- Request - Special Use Permit for a School
- Location - 1501 N Ontario Street
- Applicant - That Neighborhood Church
1501 N Ontario Street
Toledo, OH 43604
- Owner - Great Lakes District of the Christian and Missionary Alliance
2250 S Huron Parkway
Ann Arbor, MI 48104
- Engineer - Cappelletty Engineering
6145 Douglas Road
Toledo, OH 43613

The staff further recommends that the Toledo City Plan Commission recommend approval of SUP-2004-24, a Special Use Permit for a school at 1501 N Ontario Street, to the Toledo City Council, subject to the following **thirty-four (34)** conditions:

SPECIAL USE PERMIT
TOLEDO CITY PLAN COMMISSION
REF: SUP-4001-24
DATE: June 13, 2024
TIME: 2:00 P.M.

SITE PLAN

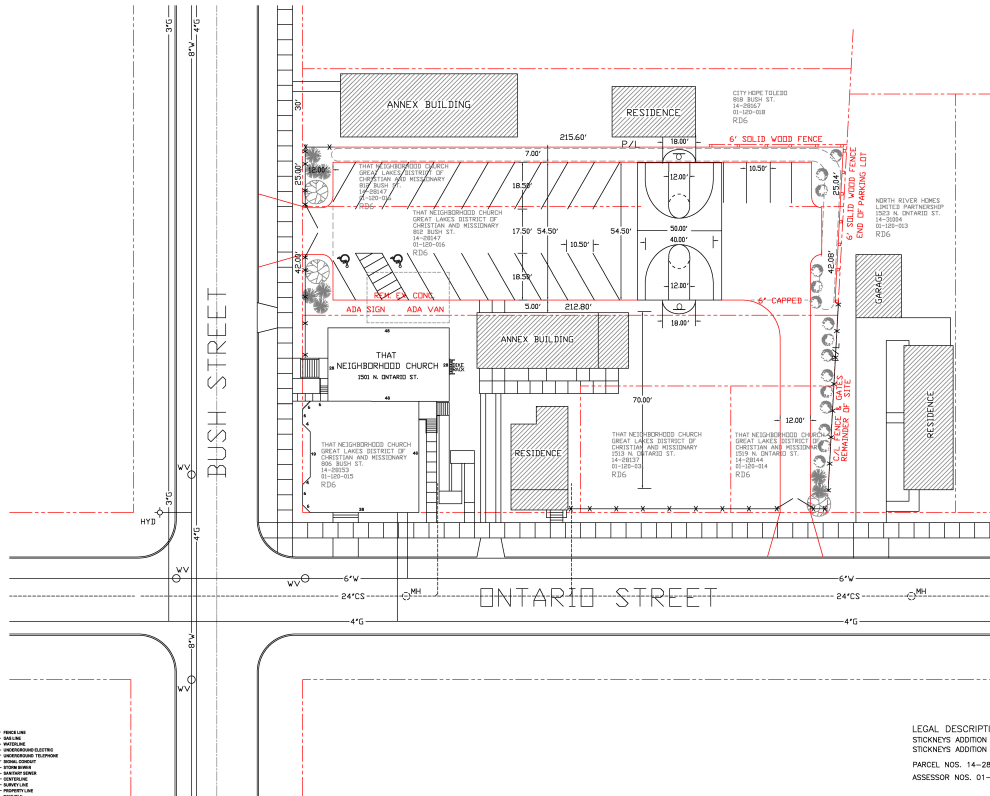
A minimum of one (1) bicycle space per ten (10) automobile parking spaces plus one (1) bicycle space per three (3) students is required pursuant to TMC§1107.0300 *Off-Street Parking Schedule "A"*. The site plan provides five (5) bicycle parking spaces. Thirteen (13) are required.

A landscaped frontage greenbelt is required along all public rights-of-way. At least one tree must be provided for every thirty feet (30') of lot frontage, rounded up. The lot has ±144 feet of frontage on Bush Street and ±207 feet of frontage on N Ontario Street, requiring five (5) trees and seven (7) trees respectfully. The site plan provides two (2) trees along Bush Street and one (1) tree along N Ontario Street. The Plan Director agrees to waive this requirement down to three (3) trees due to the existing buildings abutting the rights-of-way of Bush and Ontario Streets.

A perimeter landscape buffer is required along any parking lot area adjacent to a street, place, or driveway, or which is visible from an immediately adjacent property. On this site, a perimeter landscape buffer is required along the eastern property line and portions of the northern property line. A perimeter landscape buffer is not required adjacent to 818 Bush Street due to the property being used by the Church in an accessory manner. The perimeter landscape buffer must contain a minimum of one canopy tree for each 30 linear feet, plus a continuous row of shrubs with a minimum height of 18 inches. Privacy fencing may substitute for the shrub requirement per TMC§1108.0203(D)(2). The perimeter provides shrubs along most of the eastern perimeter and a six-foot (6') solid fence in the remaining areas. A minimum of seven (7) trees are required in the perimeter landscape buffer. Only four (4) are provided; however, one of the provided trees is existing and has an estimated caliper of twenty-one inches (21"). Per TMC§1108.0407 *Tree Preservation and Credit For Existing Landscape Materials*, this existing tree may count as six (6) trees towards the tree quantity requirement. The proposed perimeter landscape buffer is acceptable as depicted.

18. Wheel stops are required at all parking spots abutting sidewalks, property lines, planting areas and buildings per TMC 1107.1907.
19. Existing curb cut and drive approach that is no longer being utilized near exit drive on Ontario must be removed and replaced with new curb and grass to match adjacent areas.
20. Existing broken sidewalk on Ontario Street and Bush Street must be removed and replaced to match adjacent sidewalk areas.
21. Painted ground signs are required to help prevent wrong way traffic flow.
22. "Do not enter" signage is required at driveway exit on Ontario Street to prevent wrong way traffic flow.

23. Off-street parking shall be provided pursuant to Off-Street Parking Schedule "A," (TMC§1107.0304). A total of fifteen (15) parking spaces are required for this site. The submitted site plan shows twenty-three (23) parking spaces. The site may not provide more than twenty-three (23) parking spaces (150% of minimum). **Acceptable as depicted.**
24. Bicycle parking slots shall be provided pursuant to Off-Street Parking Schedule "A," (TMC§1107.0300). Minimum number of bicycle parking slots required is thirteen (13). **Not acceptable as depicted. Additional bike rack must be installed.**
